**Section 16 Planning Application for Proposed Minor Relaxation of Plot Ratio and
Building Height Restriction for Permitted Public Housing Development at
Po Shek Wu Road, Sheung Shui, New Territories**

(Application No. A/FSS/299)

Responses to Comments

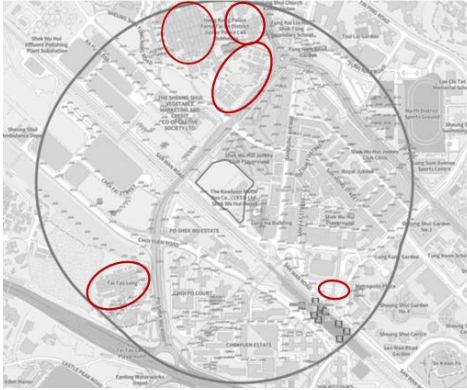
Comments	Responses
<u>Water Services Department (23.8.2024)</u>	
Existing water mains inside the proposed site as shown in the MRP may be affected. The applicant is required to either divert or protect the water mains found on site.	No diversion of water mains is proposed. The water mains found on site would be protected as per WSD's requirement.
If diversion is required, existing water mains inside the proposed site areas are need to be diverted outside the site boundary of the proposed site to lie in Government land. A strip of land of minimum 1.5m in width should be provided for the diversion of existing water mains. The cost of diversion of existing water mains upon request will have to be borne by the applicant; and the applicant shall submit all the relevant proposal to WSD for consideration and agreement before the works commence.	The water mains would not be diverted and would be protected.

If diversion is not required, the following conditions shall apply:	
(a) Existing water mains are affected as indicated on the site plan and no development which requires resiting of water mains will be allowed.	Noted. No structural elements, drainage, BS installation, landscape shall run within the water mains reserve area.

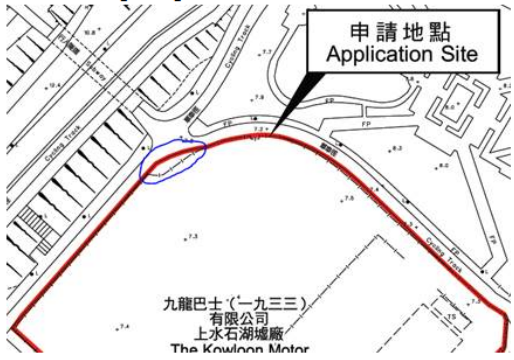
(b) Details of site formation works shall be submitted to the Director of Water Supplies for approval prior to commencement of works.	
(c) No structure shall be built or materials stored within 1.5 metres from the centre line(s) of water main(s) shown on the plan. Free access shall be available at all times for

Comments	Responses
<p>staff of the Director of Water Supplies or their contractor to carry out construction, inspection, operation, maintenance and repair works.</p>	
<p>(d) No trees or shrubs with penetrating roots may be planted within the Water Works Reserve or in the vicinity of the water main(s) shown on the plan. No change of existing site condition may be undertaken within the aforesaid area without the prior agreement of the Director of Water Supplies. Rigid root barriers may be required if the clear distance between the proposed tree and the pipe is 2.5m or less, and the barrier must extend below the invert level of the pipe.</p>	
<p>(e) No planting or obstruction of any kind except turfing shall be permitted within the space of 1.5 metres around the cover of any valve or within a distance of 1 metre from any hydrant outlet.</p>	
<p>(f) Tree planting may be prohibited in the event that the Director of Water Supplies considers that there is any likelihood of damage being caused to water mains.</p>
